ANADROMOUS WATERS CATALOG/ATLAS CORRECTION FORM

MAP: JUNEAU B-2 & B-2 NW

WATERWAY NUMBER: 111-50-10630

DESCRIBE CHANGE(S): CHANGE CHANNEL & SHORTEN

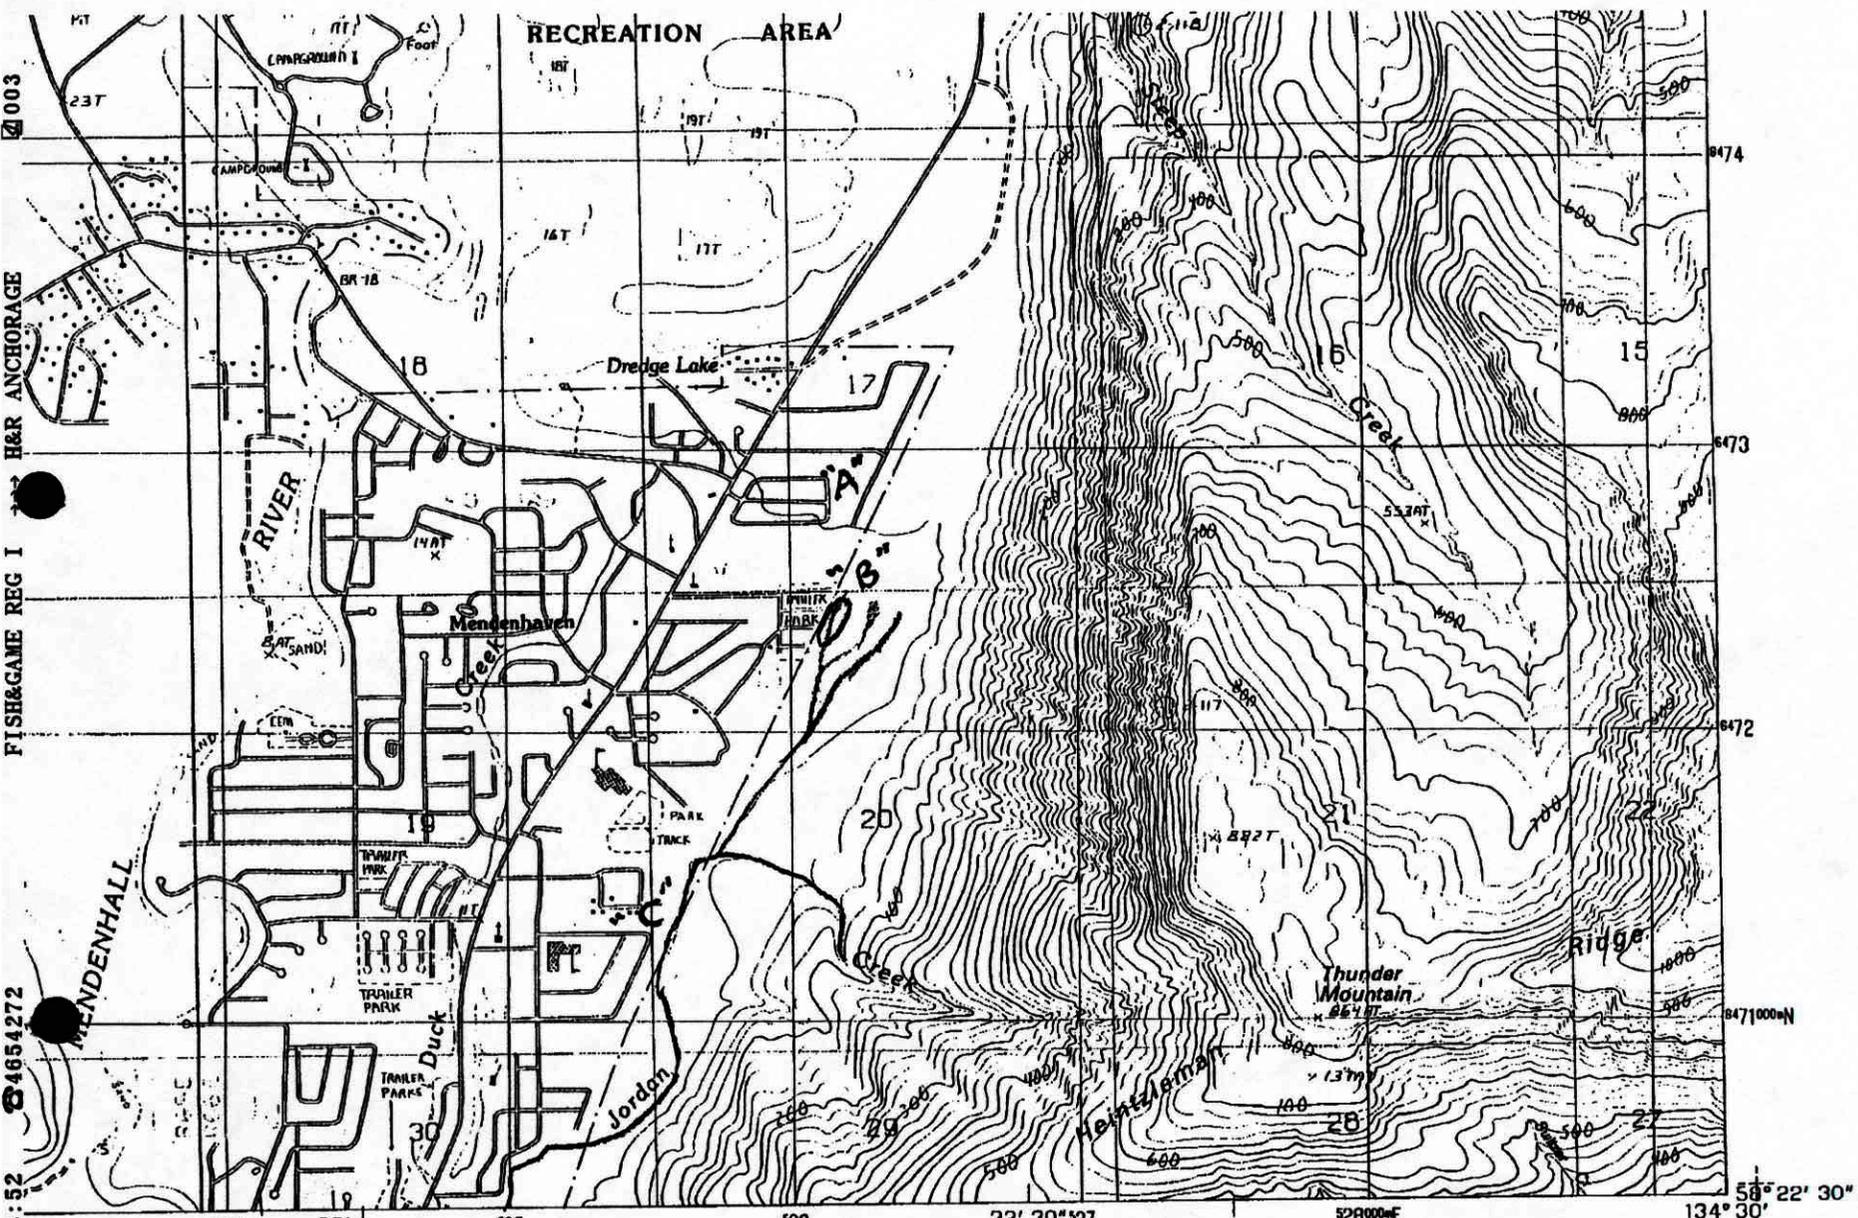
STREAM AS NOTED ON ATTACHED MAPS.

The 1:25,000 quad does a terrible job of showing Jordan Cr. headwaters. Got your fax. The stream never extends past the northern end of the trailer park. That transcribed version is way off. It shows fish in a subdivision.

As I stated in the attached memo, Sport Fish's file doesn't provide much detail in the headwaters area but it is some of the most important rearing habitat in Jordan Creek for coho. Currently, escapement is down from an average of 250-300 to about 20 because of habitat decline. We are reviewing a project in this area. It has been disturbed for many years. Ditches have been constructed for drainage that run directly into Jordan Creek. This part of Jordan Creek was likely a natural drainage before it was deepened. It has good groundwater upwelling and juvenile coho like it.

Bethers et al. (1995) doesn't provide capture data on the "west headwater" tributary. I caught 9 coho in a very short set time. On the Juneau B2 NW quad they don't even show a creek in this area but it is alongside the trailer park.
